## HISTORIC AND DESIGN REVIEW COMMISSION

January 16, 2019

**HDRC CASE NO:** 2019-003  
**ADDRESS:** 210 W PEDEN ALLEY  
**LEGAL DESCRIPTION:** NCB A63 BLK LOT W 376 FT OF E IRR 849.82 FT OF S 128.84 FT OF 1 ARB 3C  
**ZONING:** I-2, H  
**CITY COUNCIL DIST.:** 1  
**APPLICANT:** RJ Paez/Open Studio  
**OWNER:** Shue Properties LLC  
**TYPE OF WORK:** Exterior modifications, construction of additions  
**APPLICATION RECEIVED:** January 16, 2018  
**60-DAY REVIEW:** March 17, 2019  
**REQUEST:**

The applicant is requesting a Certificate of Appropriateness for approval to perform exterior modifications to the existing structure including repairs to the metal canopy, the installation of an ADA ramp, exterior modifications including the creation of fenestration openings within the existing façade. Other modifications will include the resurfacing of the parking lot and a swimming pool as well as a wrought iron fence.

**5 TYP. FENCE ELEVATION**  
SCALE: 1/2" = 1'-0"

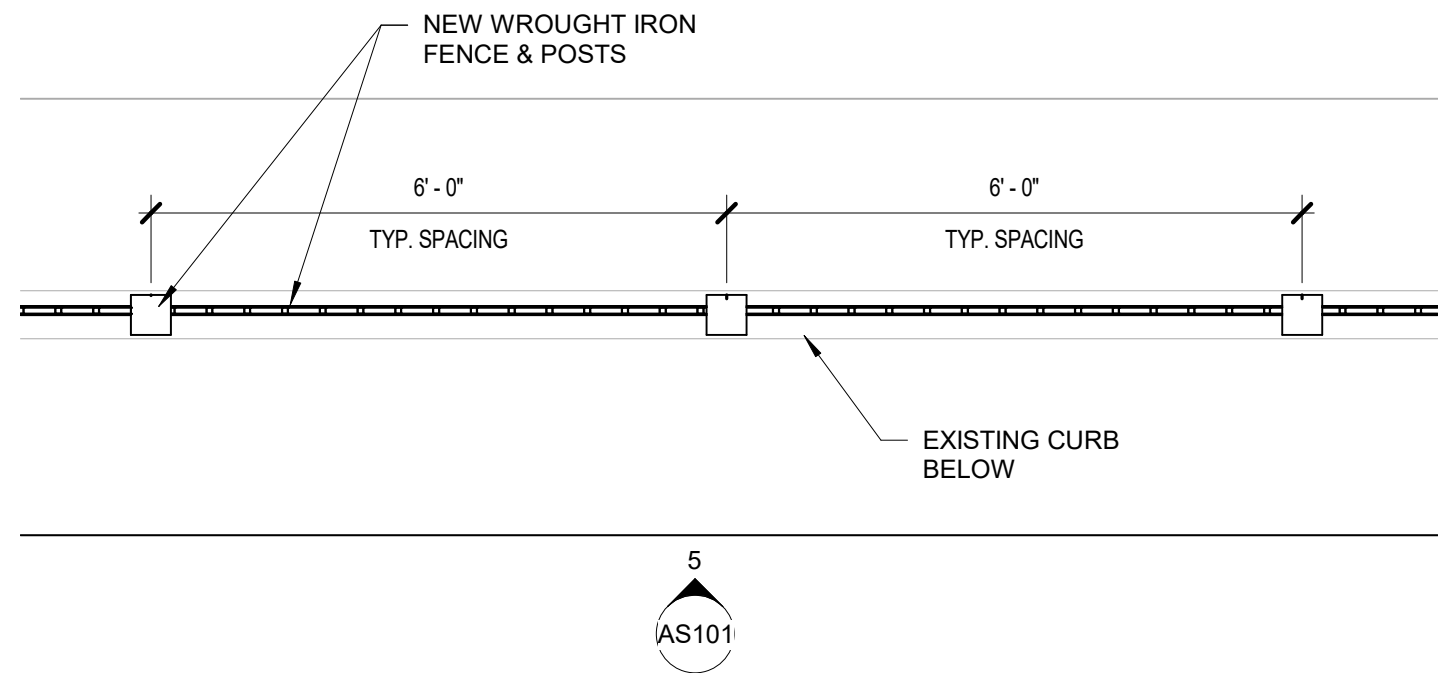
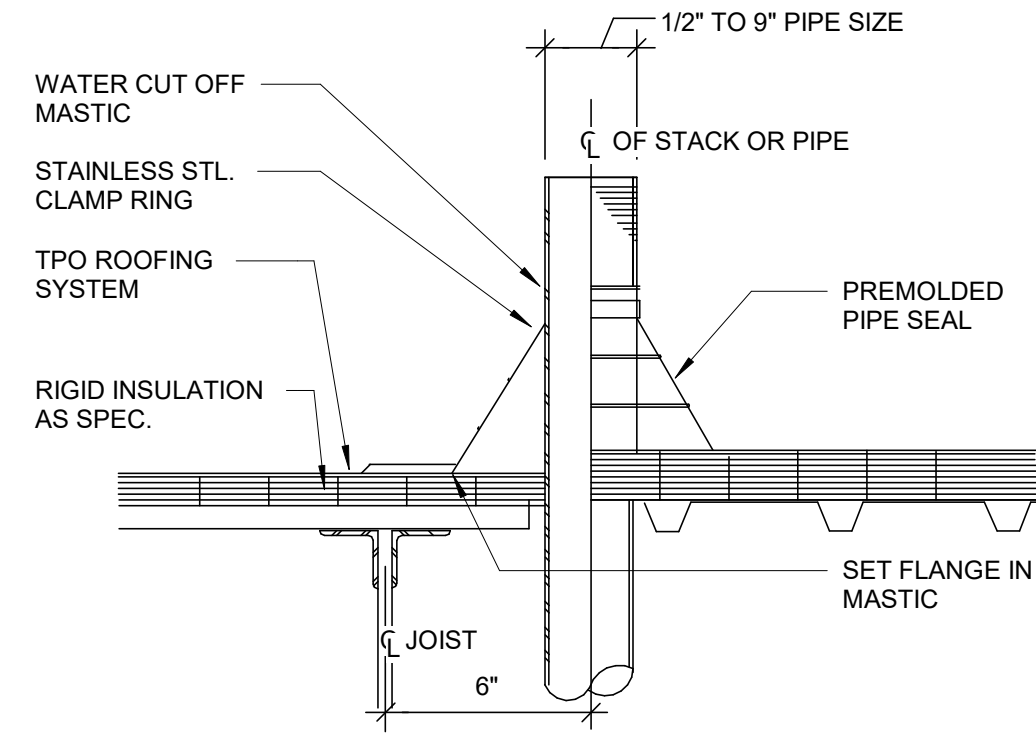
- i. That all windows are recessed at least two inches within walls.
- ii. That the proposed fencing not exceed six (6) feet in height at any location on the site.

drawing title:  
EXTERIOR ELEVATIONS

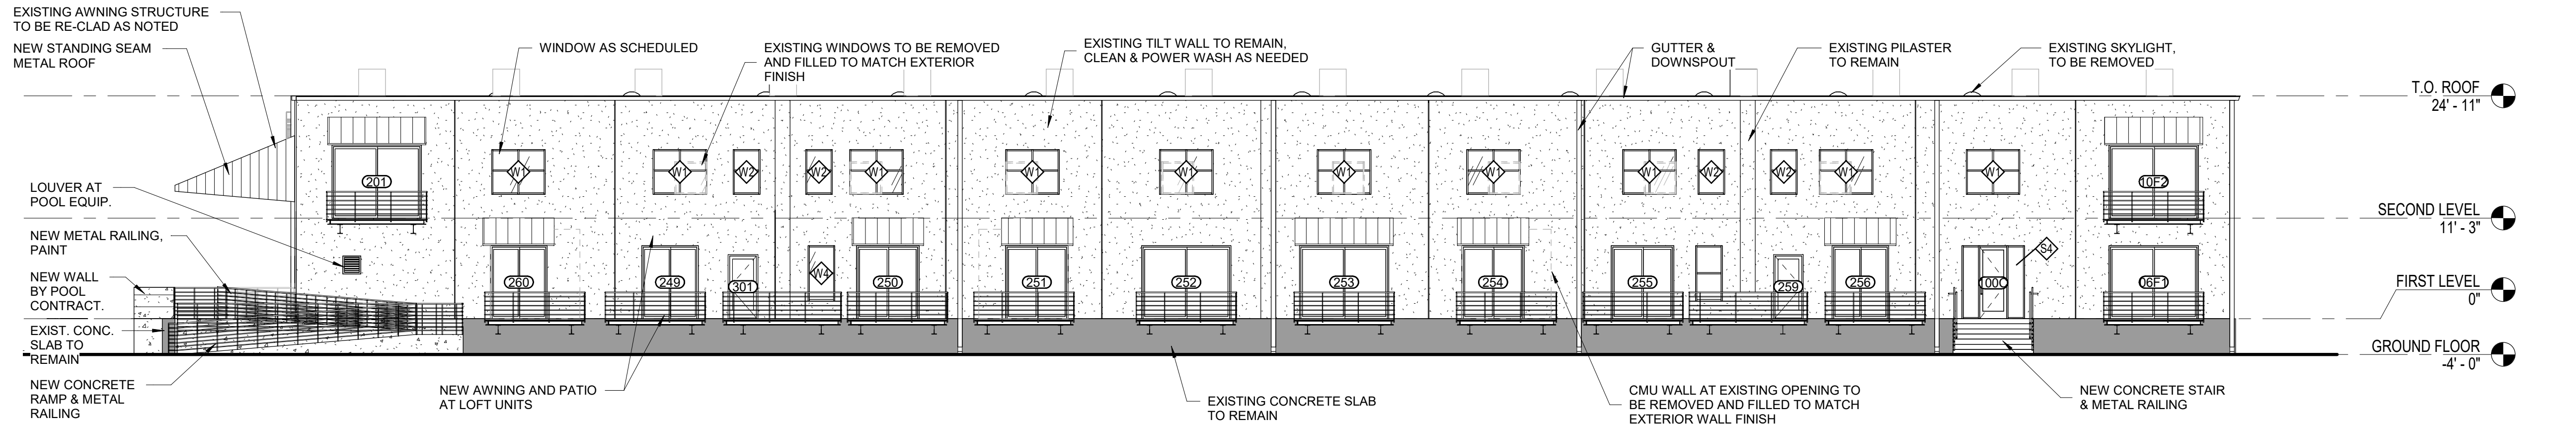
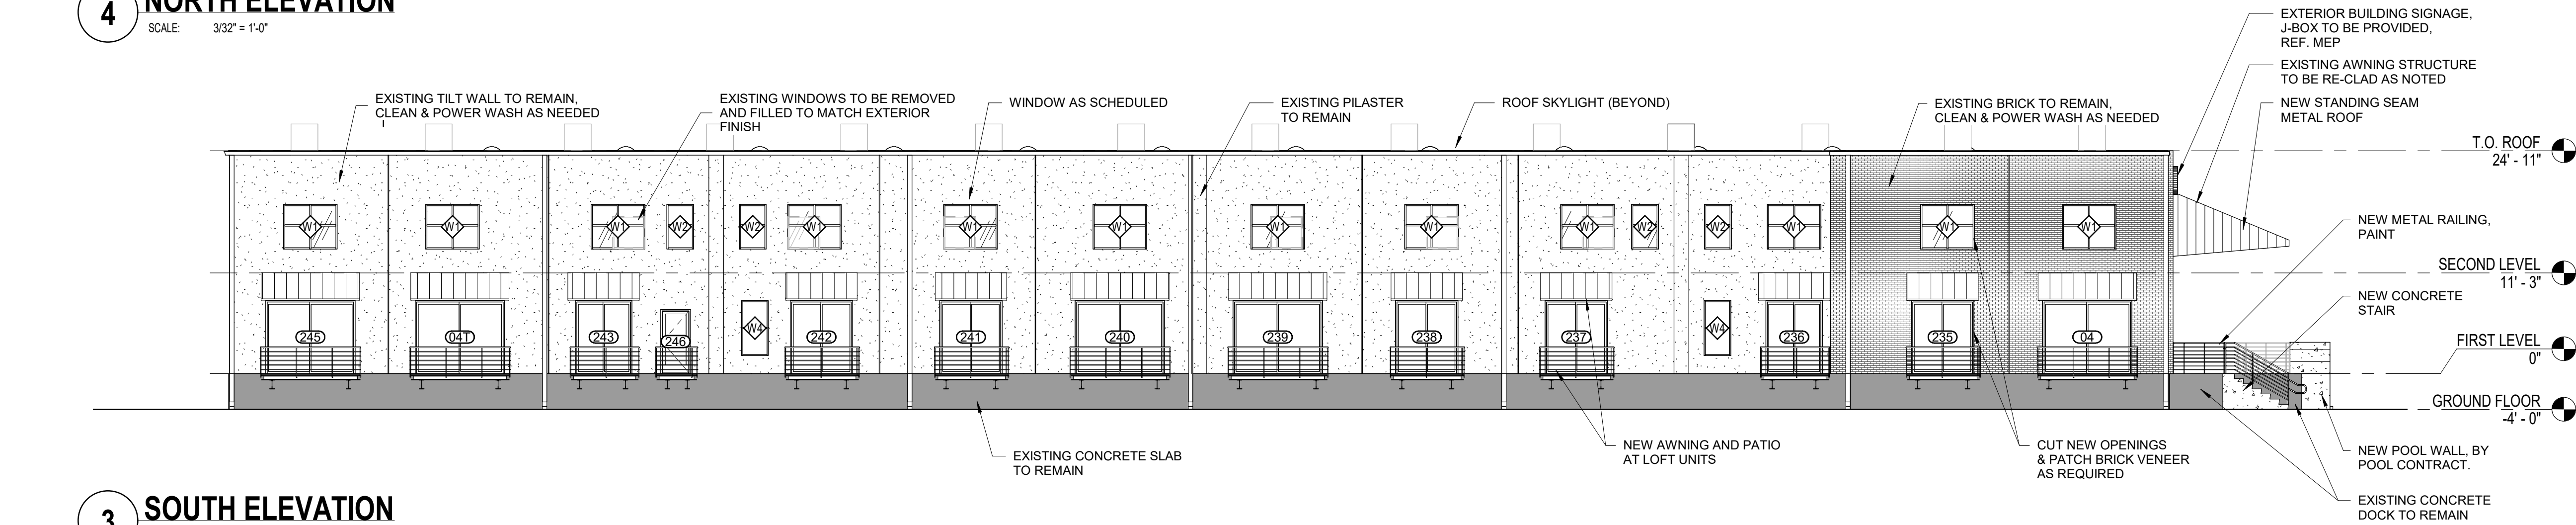
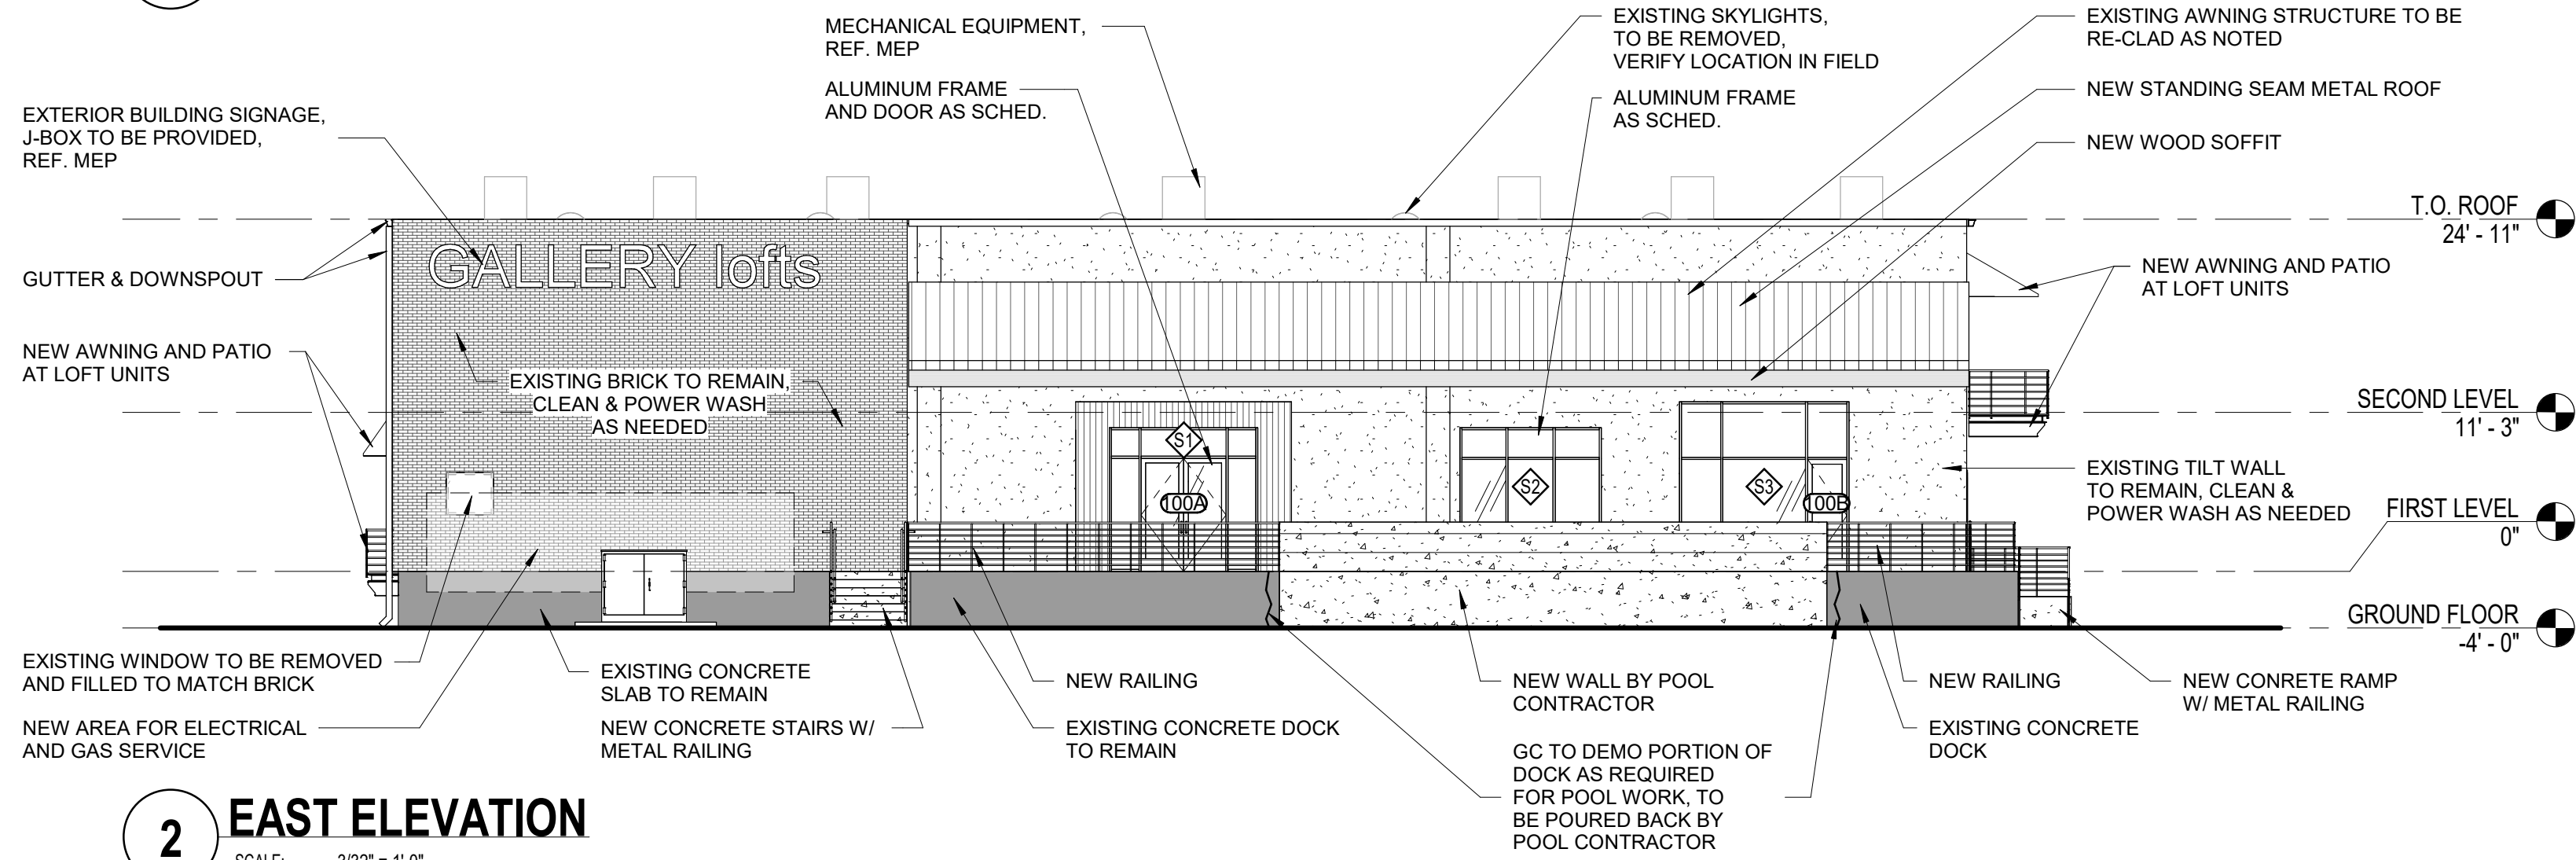
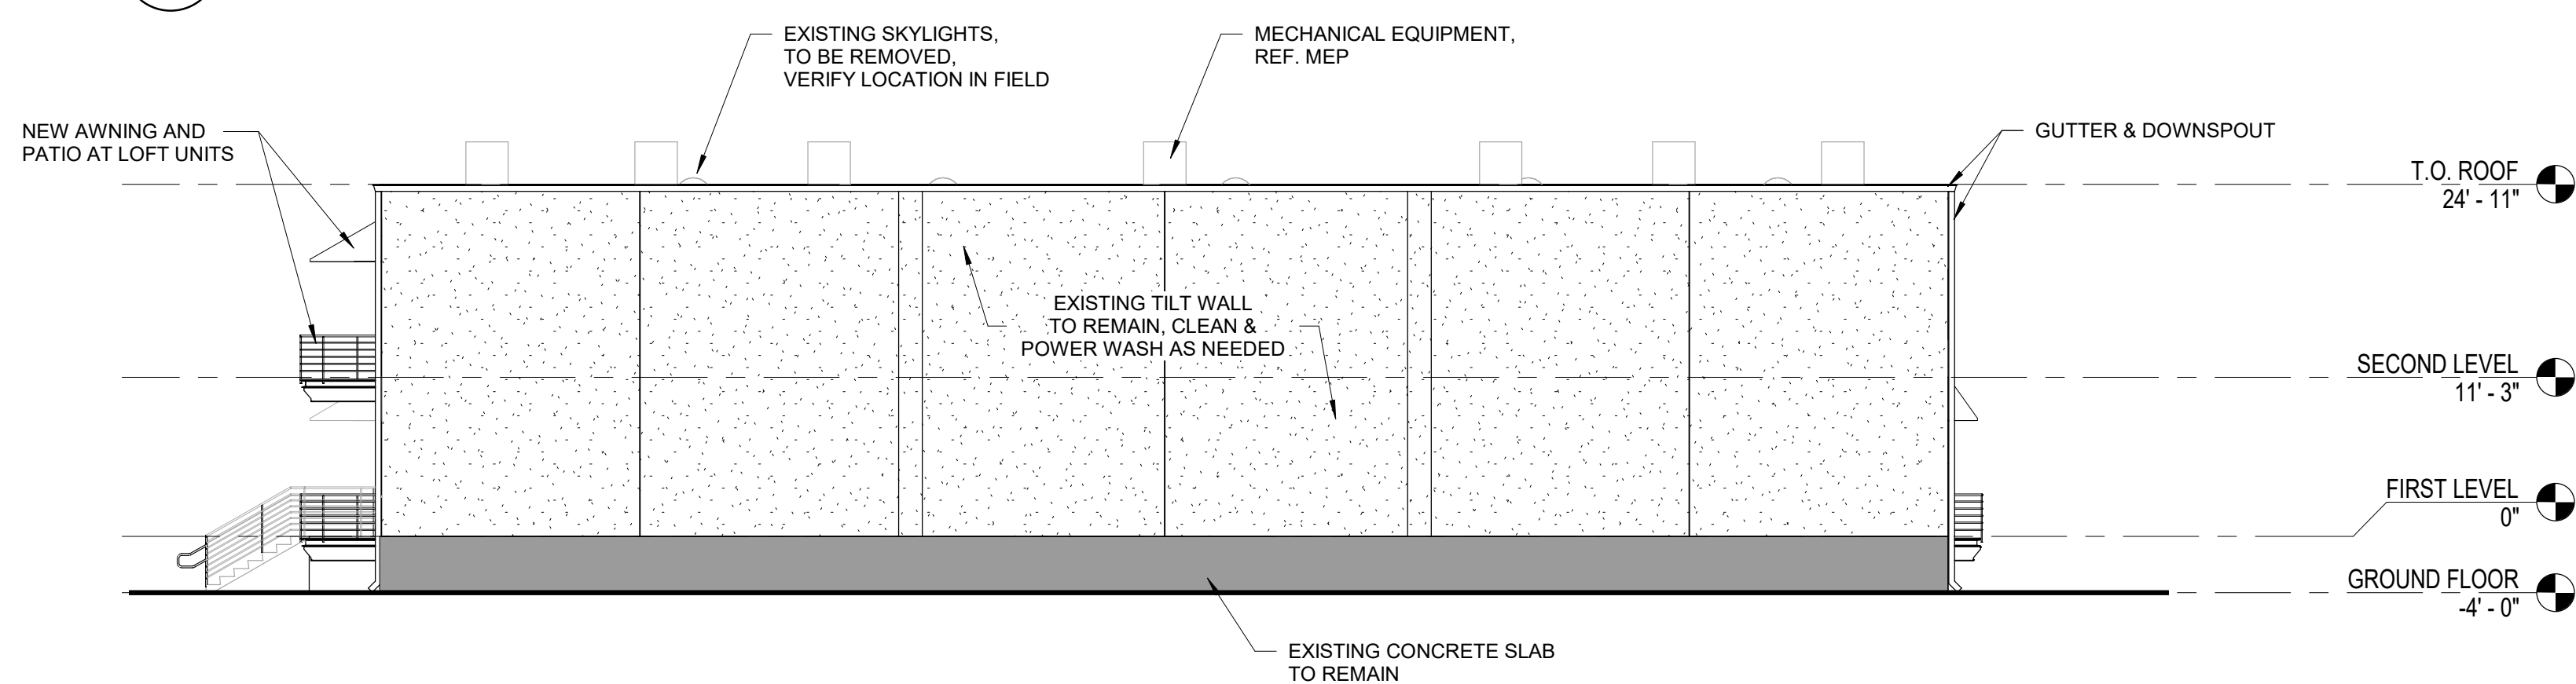
- b. HUMAN SCALE – According to the UDC Section 35-674(b) a building shall appear to have a “human scale”. To comply with this, a building must (1) express façade components in ways that will help to establish building scale, (2) align horizontal building elements with others in the blockface to establish building scale, (3) express the distinction between upper and lower levels, (4) in this instance, divide the façade of the building into modules that express traditional and (5) organize the mass of a building to provide solar access to the river. While the structure is existing, the proposed exterior modifications create a human scale that previously did not exist.
